MEMORANDUM

Date: January 06, 2015
To: David Bonk, Kumar Neppalli, PE
Town of Chapel Hill, North Carolina
From: Bill Schultheiss, PE
Re: South Columbia Street and Otey's Road Safety Review and Concept Development

Toole Design Group (TDG) was retained by the Town of Chapel Hill to review a concept design developed by Kimley-Horn and Associates, Inc. (KHI) at the northern intersection of South Columbia Street at Fordham Boulevard (attached as exhibit 2), to develop concept design alternatives for South Columbia Street from Purefoy Road to Culver Road, and to develop a crossing improvement concept for Otey's Road at Fordham Boulevard.

SHEET NAME:
 S. COLUMBIA AT
 FORDHAM BLVD
 WESTBOUND RAMP
 DRAWING NUMBER
SK-1
 SHEET NUMBER
1 OF **13**

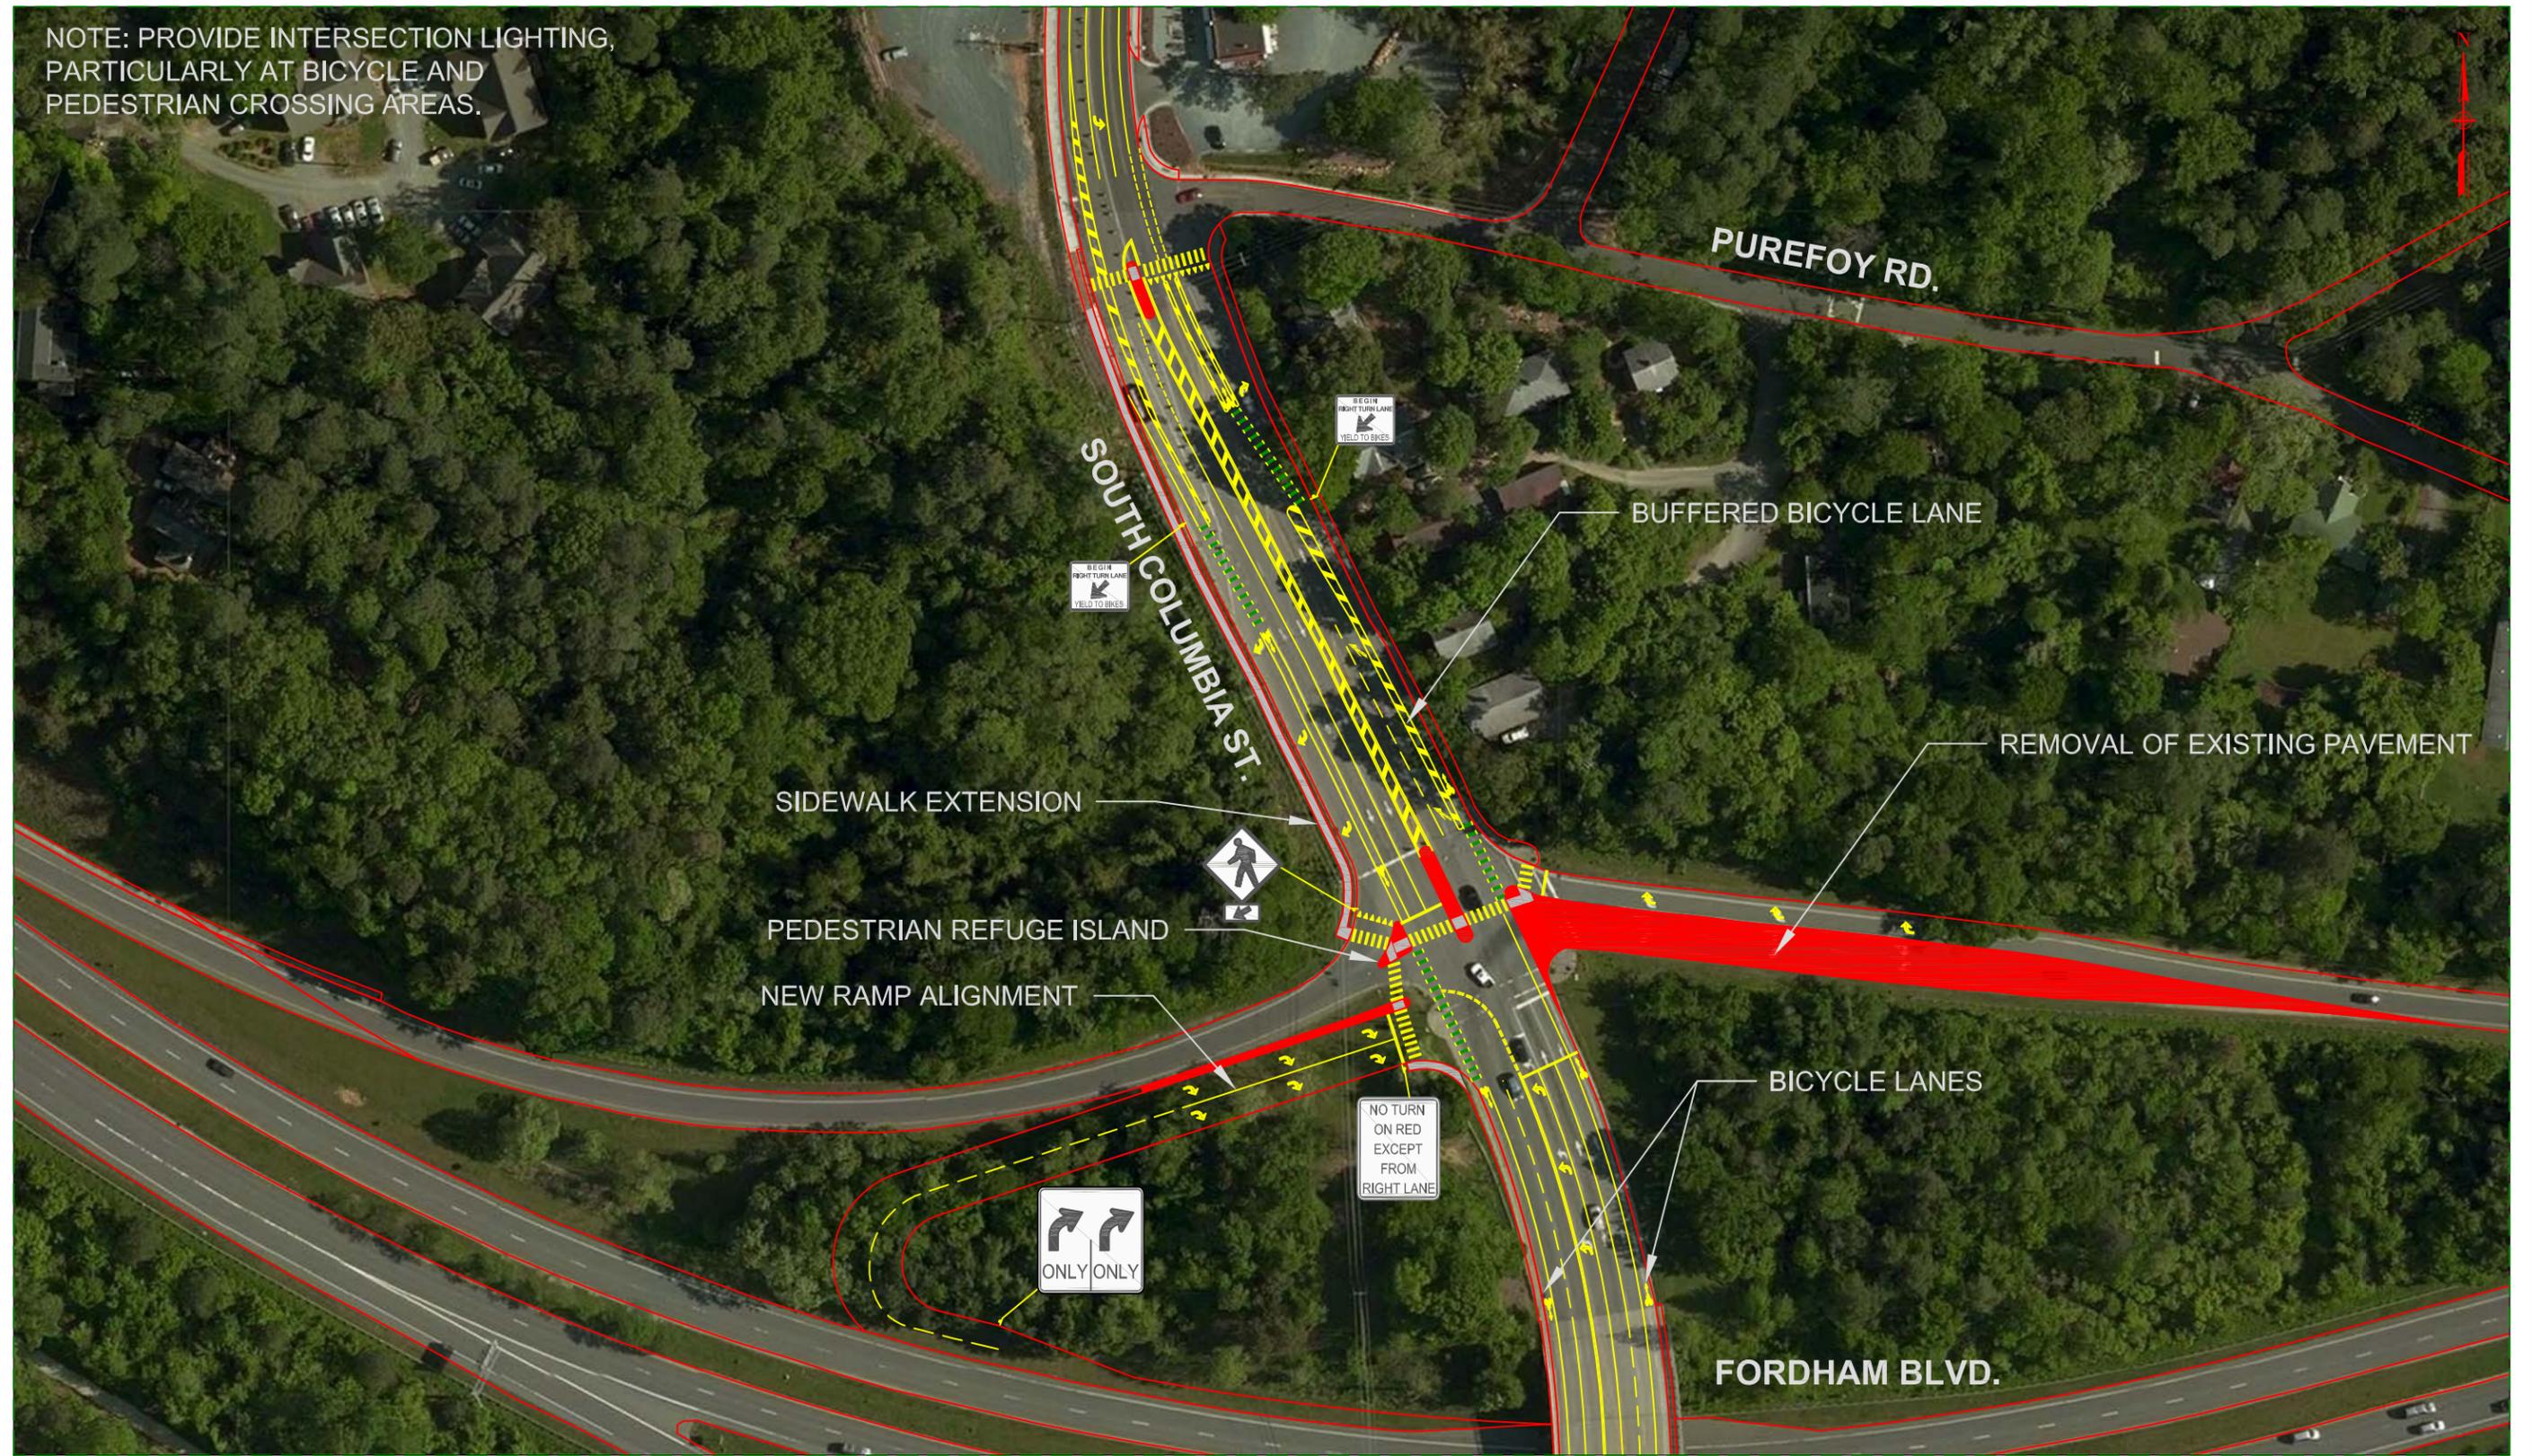
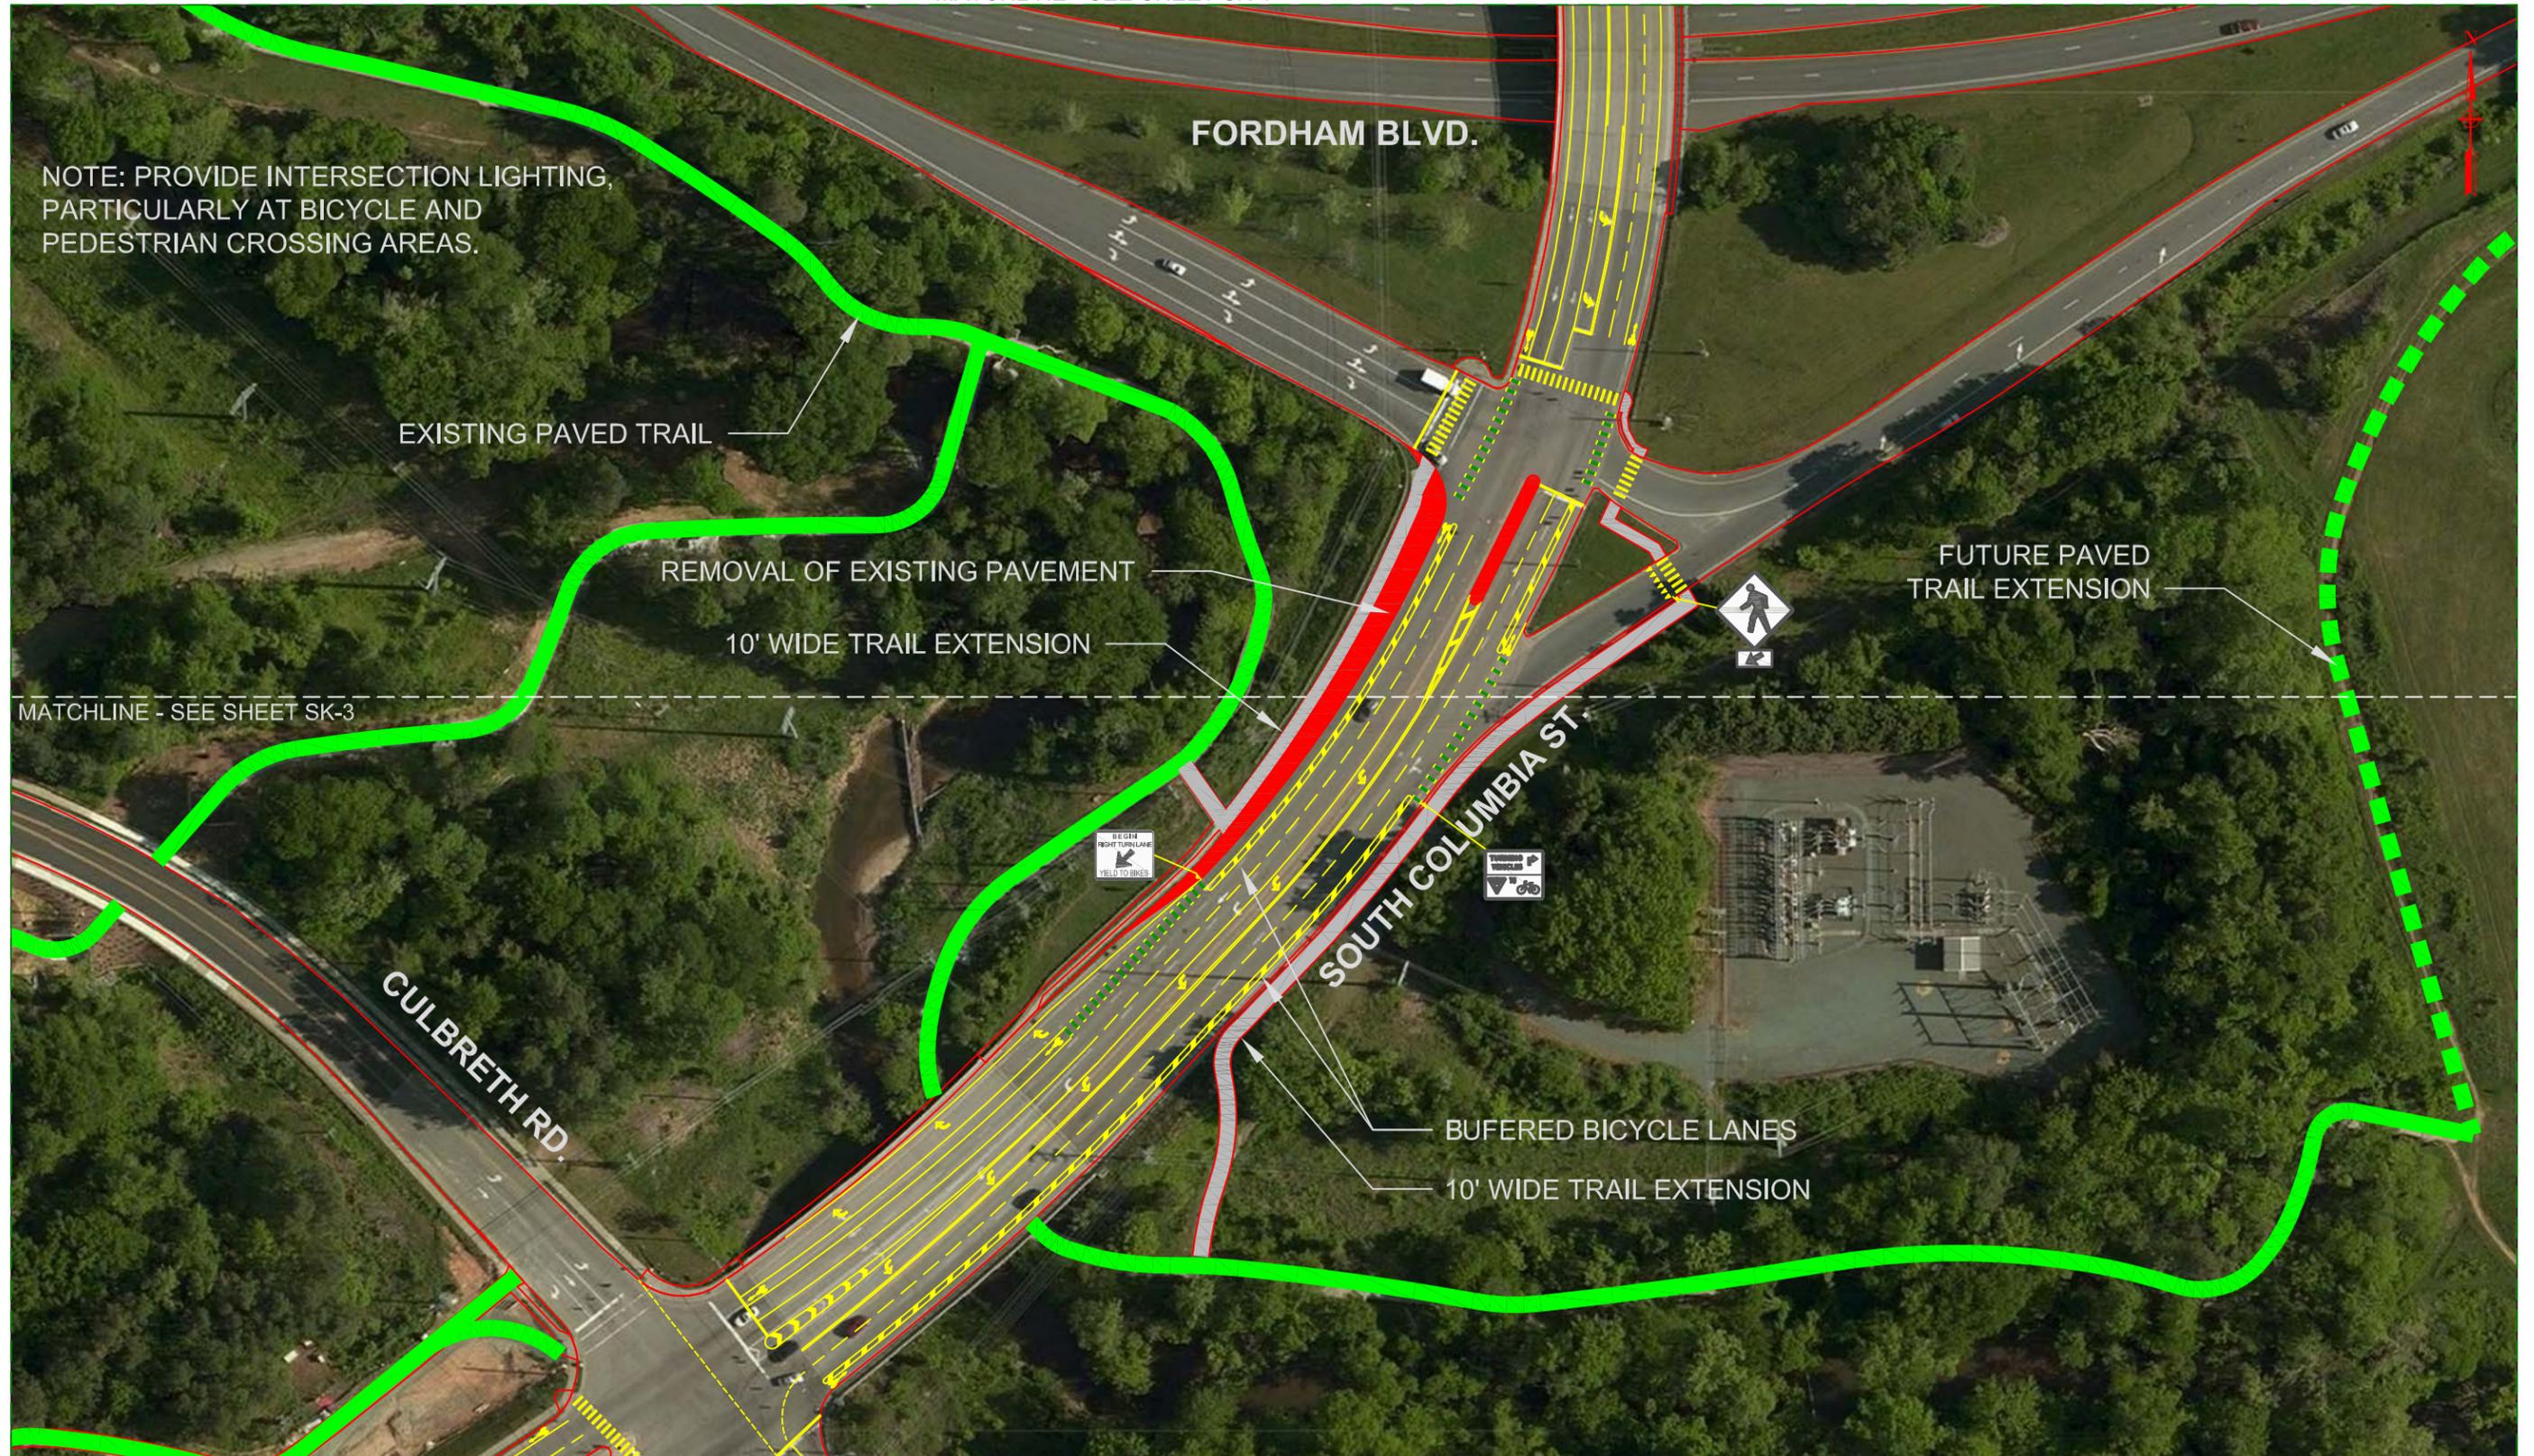
Alternative 1 depicts modest changes to the KHI design. The slip ramp designs remain in place for the southbound and northbound on-ramps to Fordham Boulevard. Adjustments to curbs are recommended to remove free flow traffic from the proposed westbound to southbound off ramp.

- Signal, stop control, or yield control for each on and off ramp is recommended in that prioritized order of consideration to ensure pedestrians and bicyclists have safe crossing opportunities;
- Modify intersection geometry for the northern intersection of South Columbia Street at Fordham Road to:

- allow a WB-62 to utilize the full width of the receiving roadway for turns, (recognizing this is a small percentage of the traffic);
- consider restriction of right-turn-on red for trucks which will need larger gaps in traffic if the dedicated receiving lane is not provided;

- to reduce likelihood vehicles queue into the through lanes on Fordham Boulevard⁵ the westbound to southbound off ramp provides a double right turn lane (shown on concept); this may require this may require trucks to control both lanes to make the right turn;

- It may be further necessary to lengthen the deceleration lane from Fordham Boulevard east of the the South Columbia Bridge. It appears space is available if the travel lane can be located in close proximity to the existing bridge support column.

- A median refuge is provided for the new northern crosswalk;
- Modify intersection geometry for the southern intersection of South Columbia Street at Fordham Boulevard;
